Comment: Produced water tank has no tank sign/placard (IMG 06 and IMG 07).

Picture from INC showing the unused equipment on location.

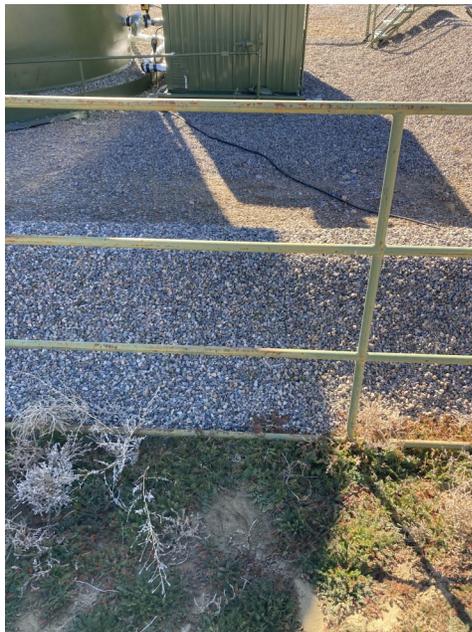
Comment: Trough, 2" pipe. and pipe attachment at 2-17 wellhead are not in use. Unused wire fencing at produced water tank (IMG 04).

Corrective Action: All unused equipment must be returned to use or stored off location per rule 606. **Date:** 11/15/2022
